ARMED FORCES RADIOBIOLOGY RESEARCH INSTITUTE

SUBJECT: Submission of Annual Report

1993  
Annual Report  
of the  
AFRRI TRIGA Reactor

Docket 50-170

Figure 2.15--Core Support Carriage Interlocks

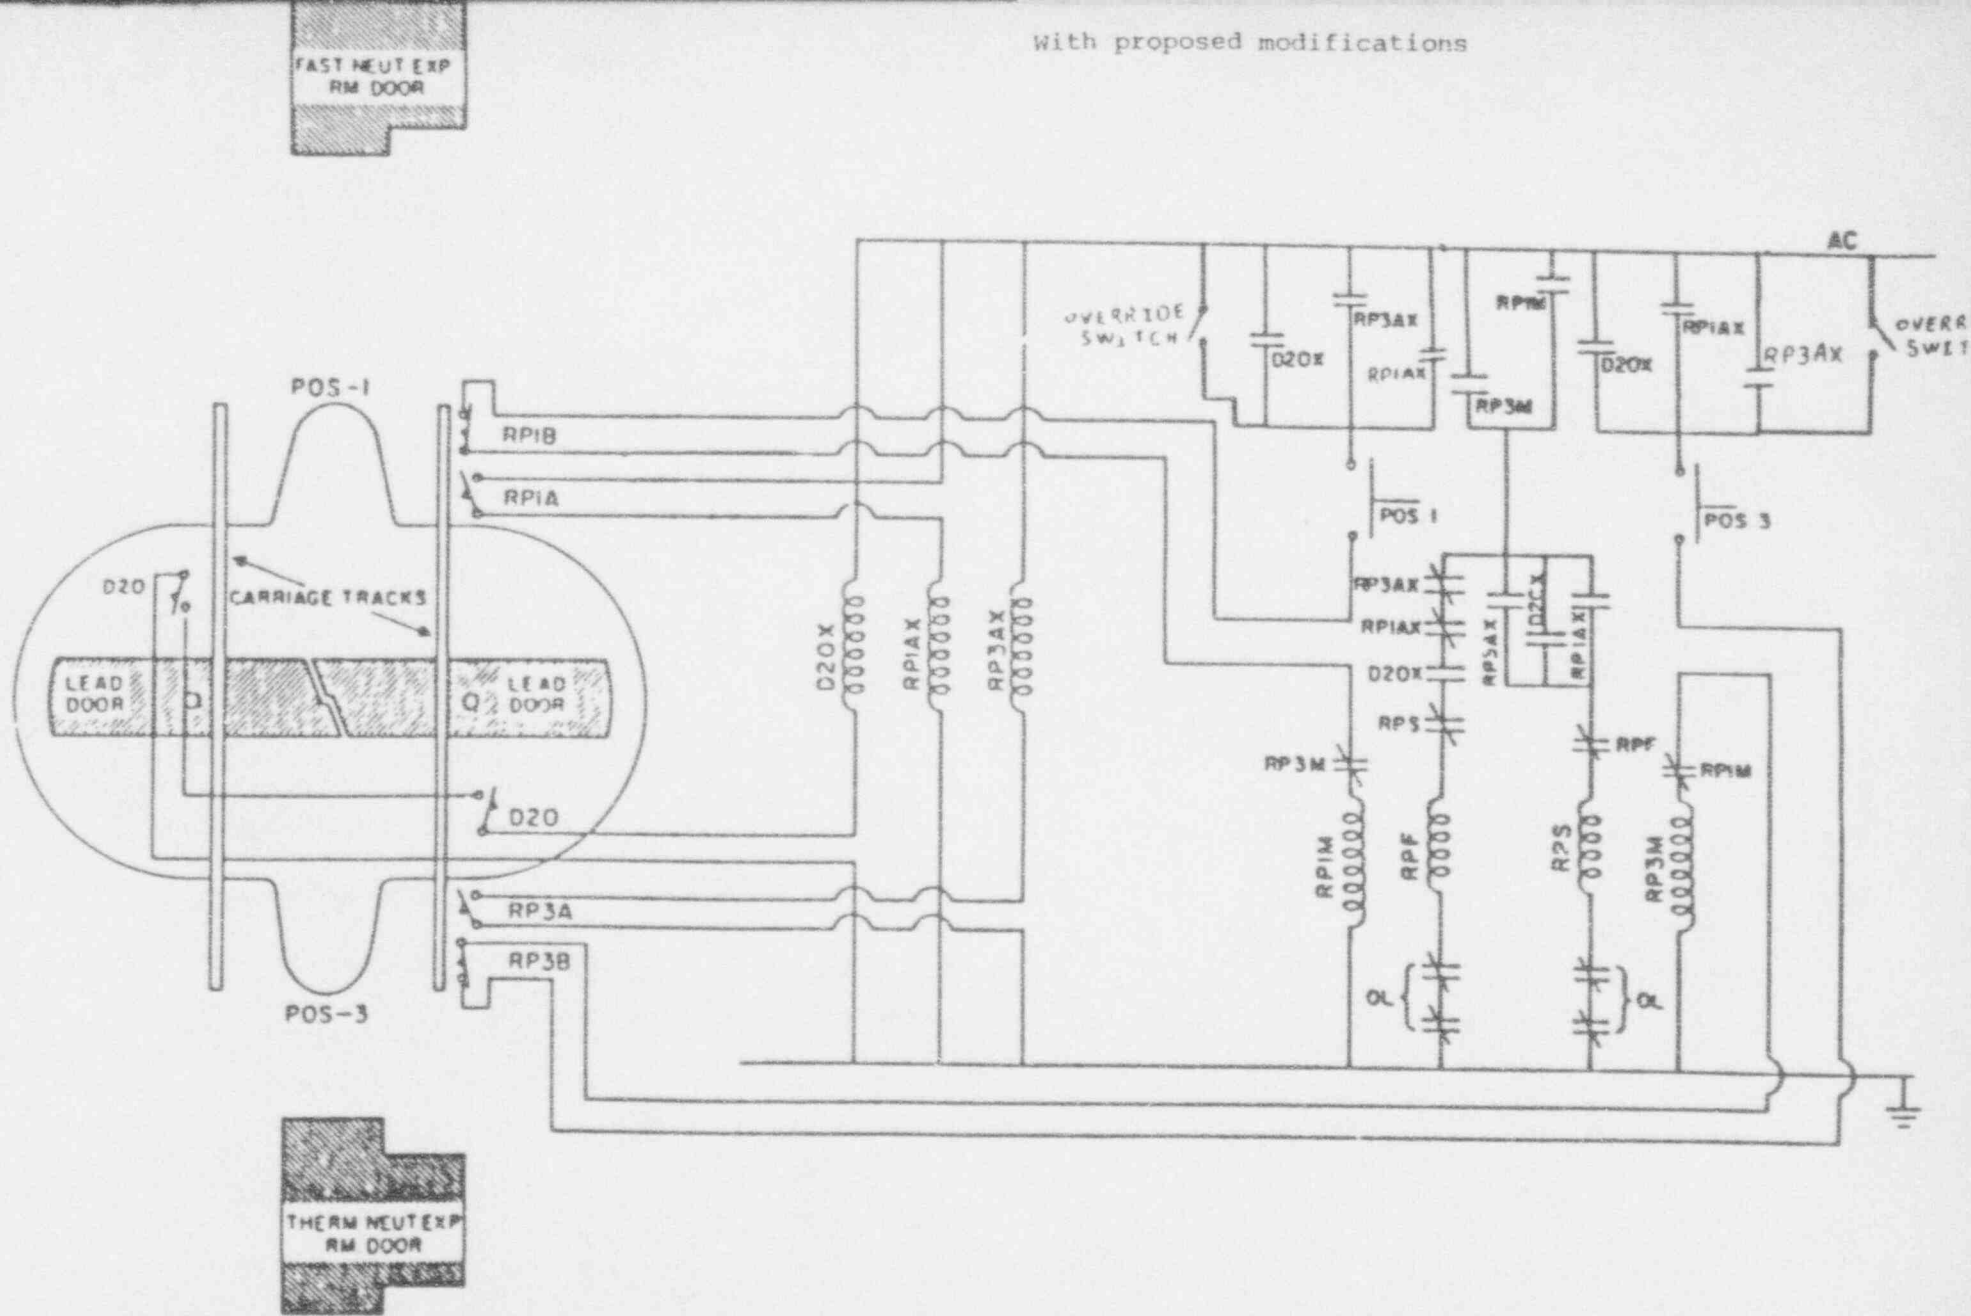
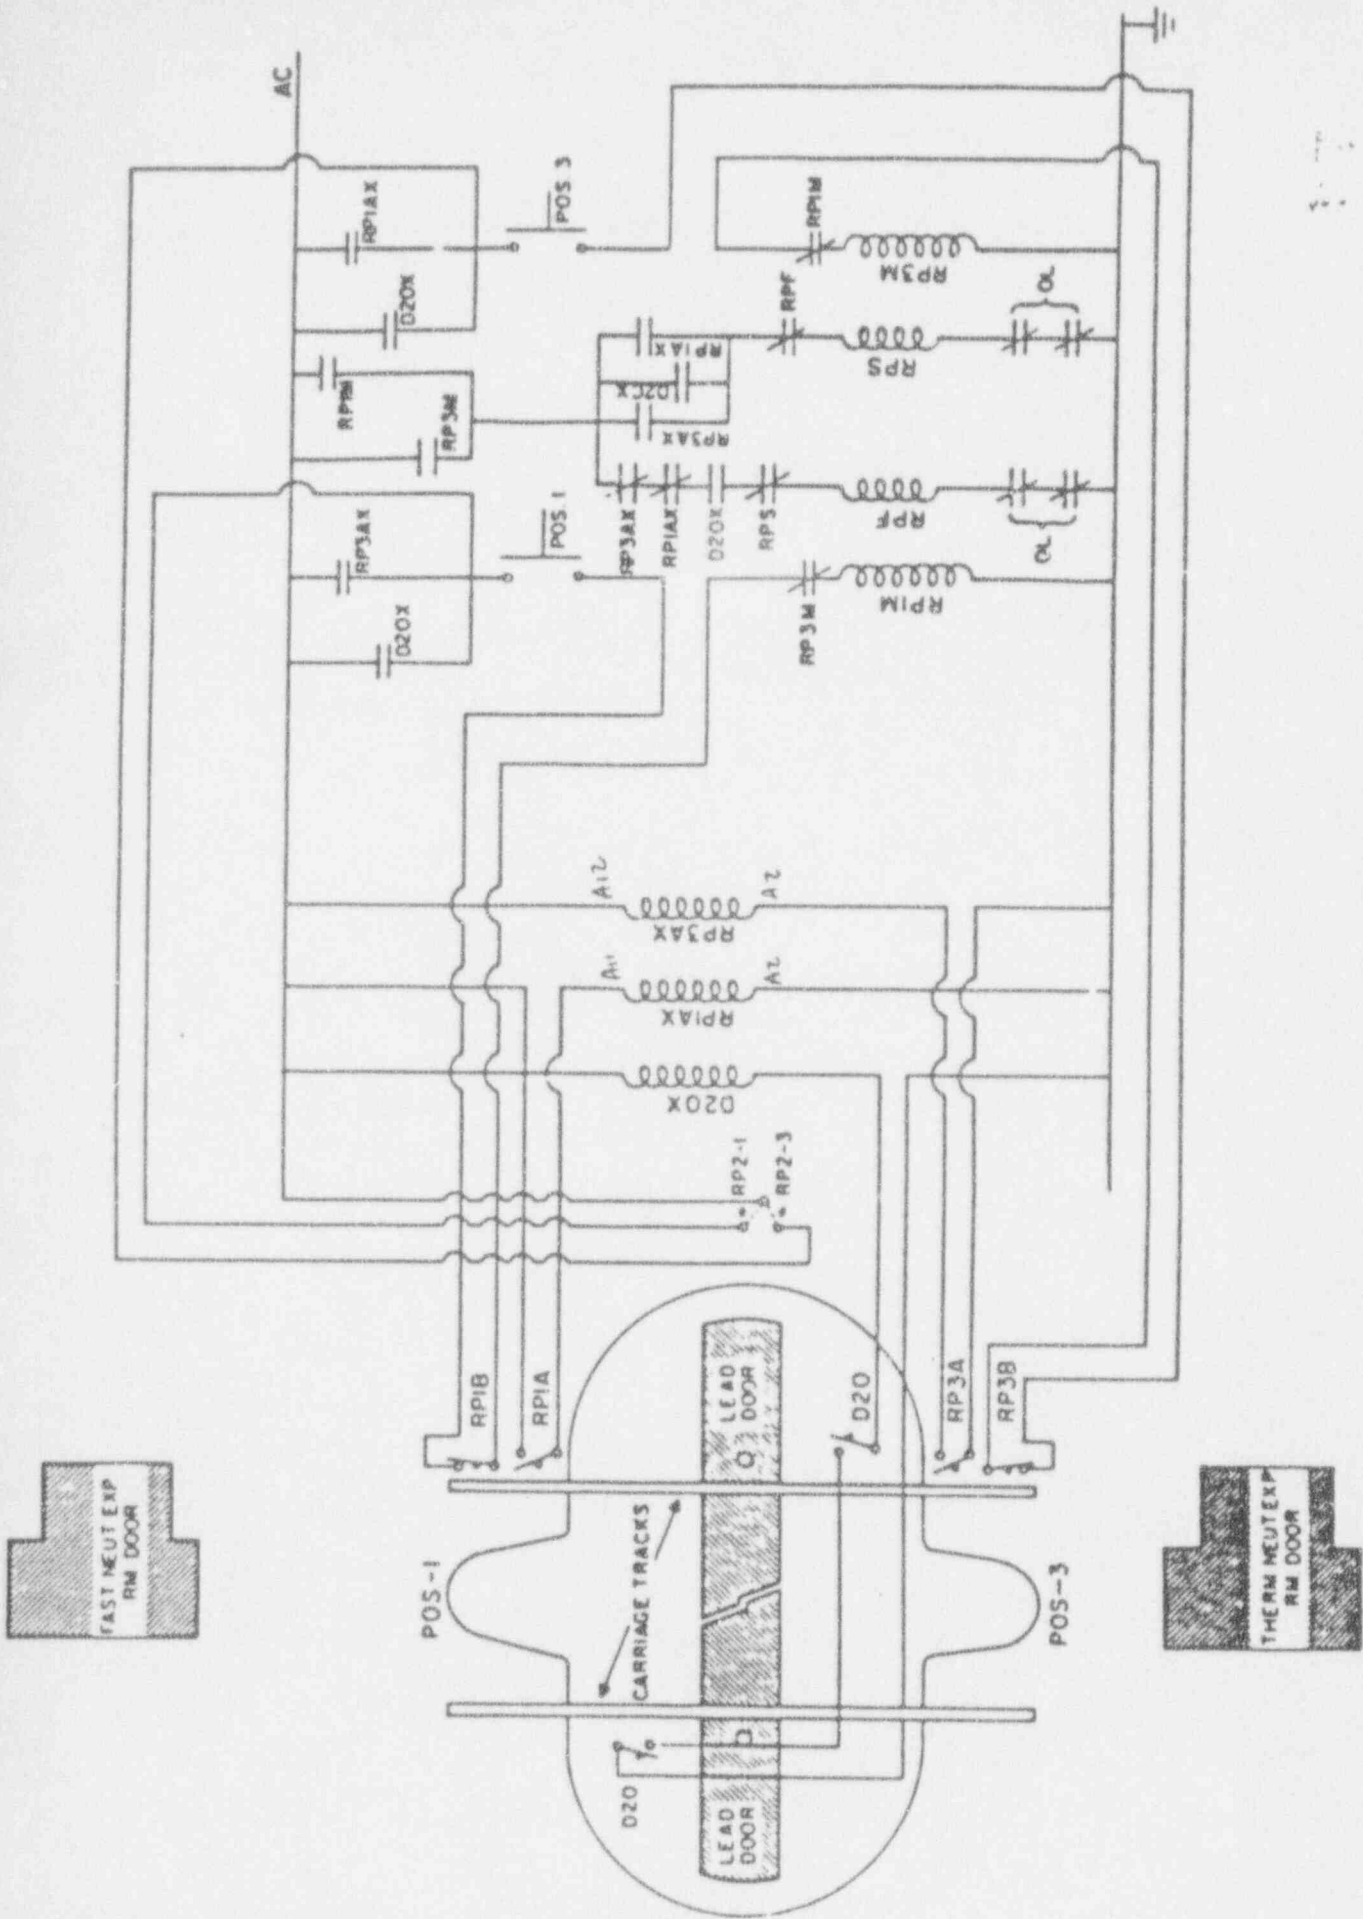
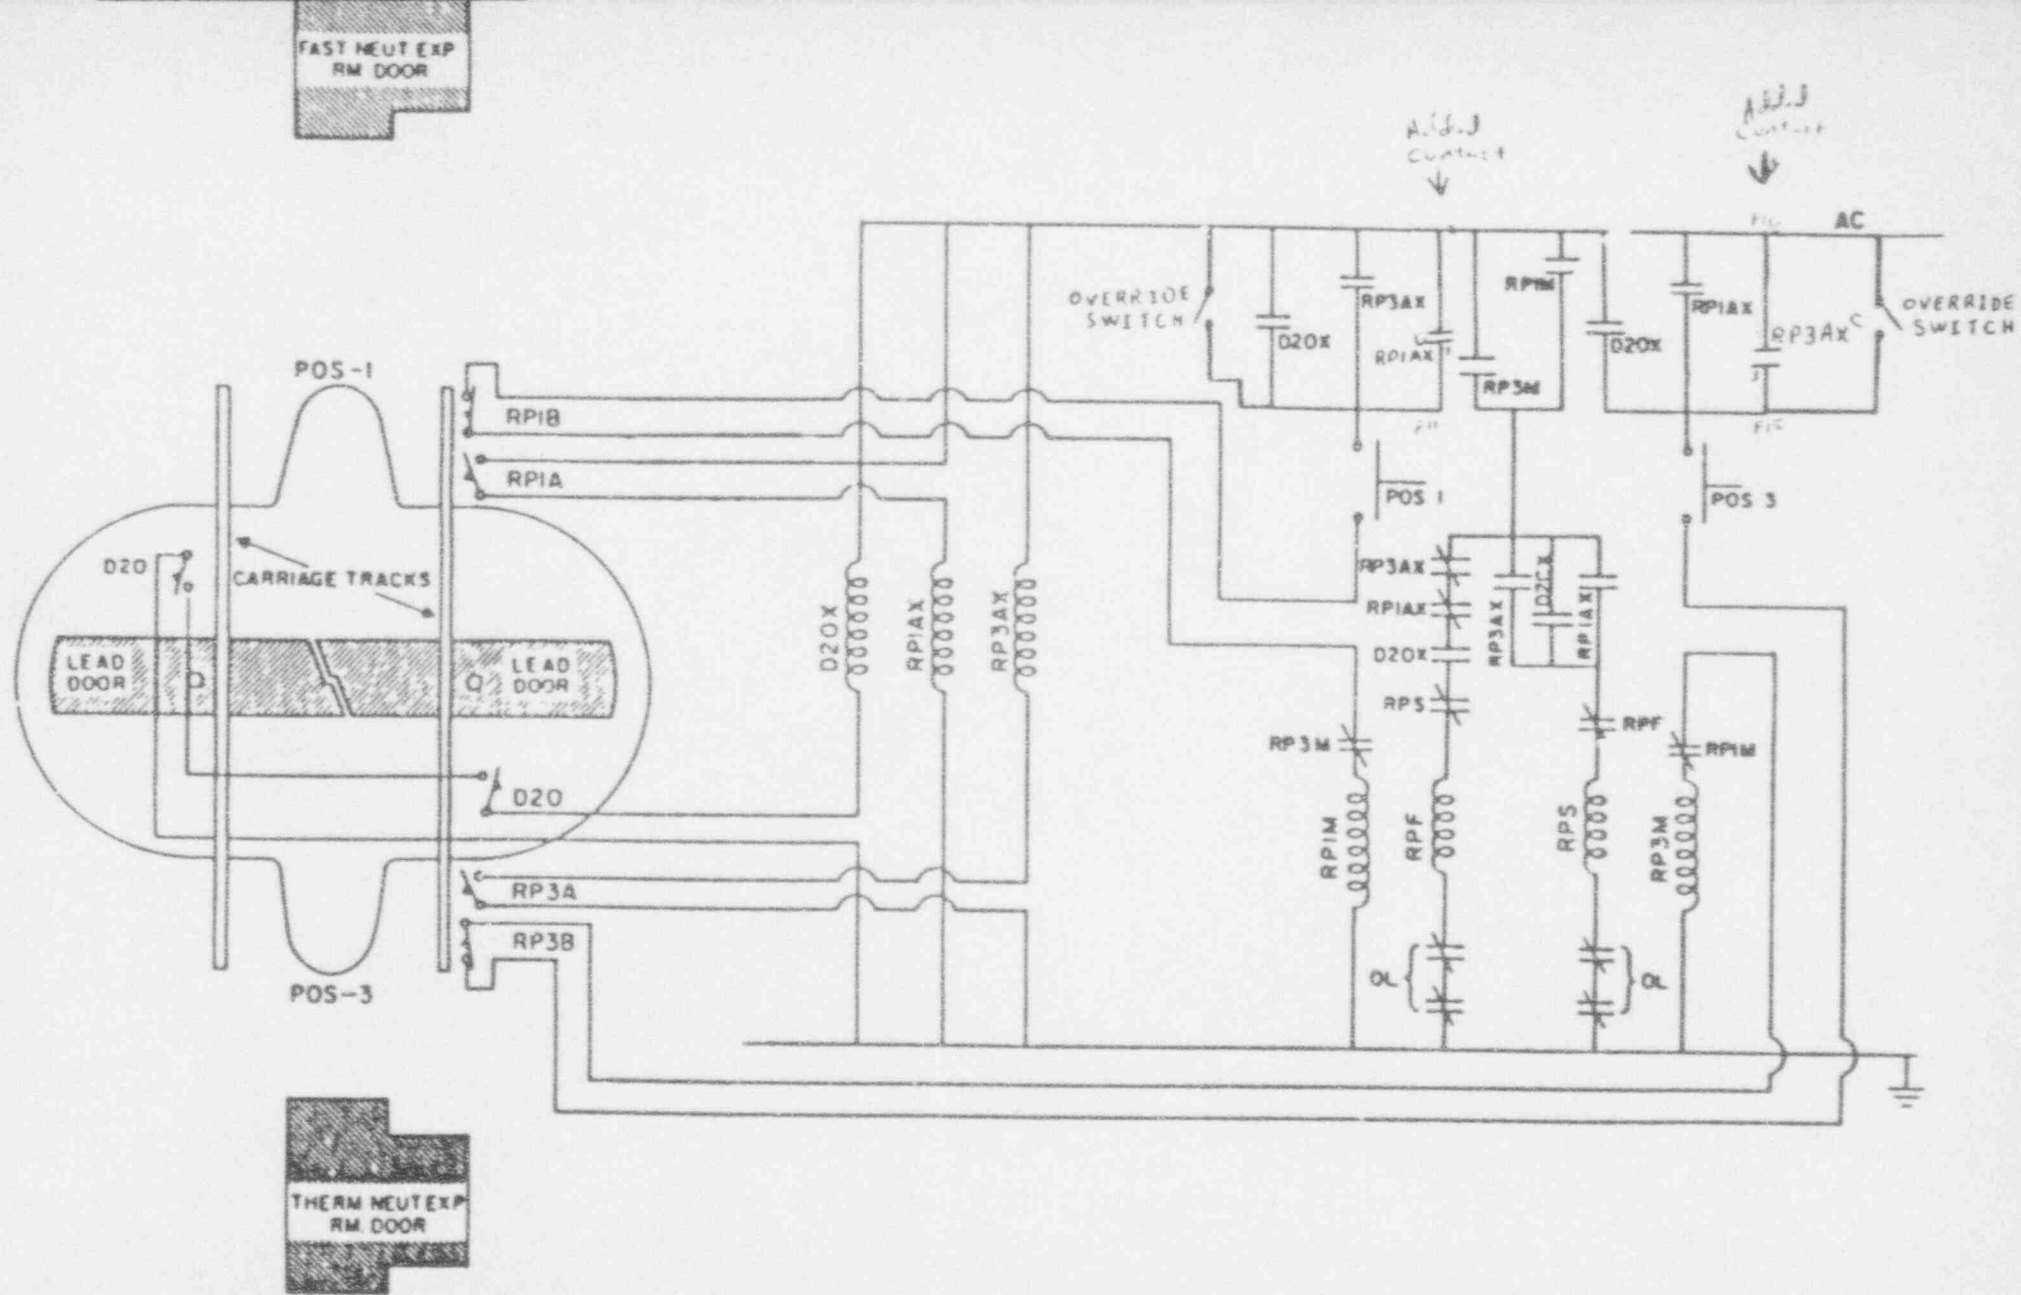
Proposed Change Replacement of switch RP2 with relays RP1AXC and RP3AXC

5. List of associated drawings, procedures, logs, or other materials to be changed: The facility interlock drawings will be modified to reflect the wiring changes described on the attached drawing
